EO 71-001 Installation of Safety Guards on IBF Remote Panel

EC135 T2/P2 (CPDS), EC135 T2+/P2+, EC135 T3/P3 (CPDS) with IBF Remote Panel installed

Before EO 71-001	After EO 71-001

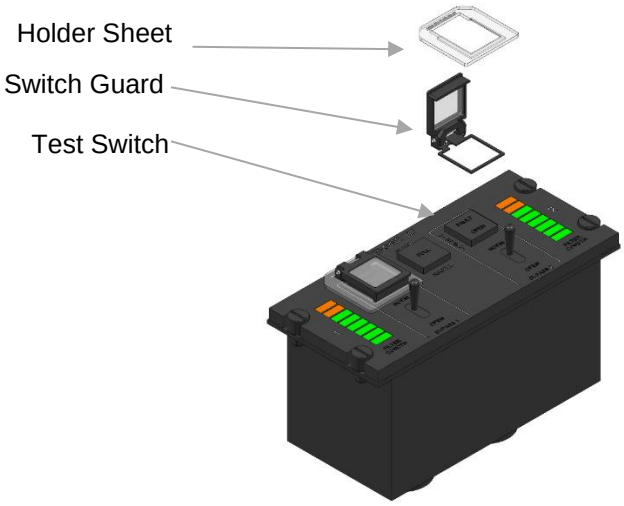
With this Engineering Order, two Safety resp. Switch Guards for the Test Switches of the standard AHD EC135 IBF Remote Panel (P/N L716M10A1001 or eq. – refer to **Fehler! Verweisquelle konnte nicht gefunden werden.**) are installed to eliminate the possibility of triggering an unintended self-test of the IBF system when the H/C is on ground resp. when the Collective Lever is latched.

The Switch Guards for both Test Switches are installed on the IBF Remote Panel under the use of a Holder Sheet. This sheet does not affect the visibility, even in NVIS conditions. This EO can be removed if required with a described procedure.
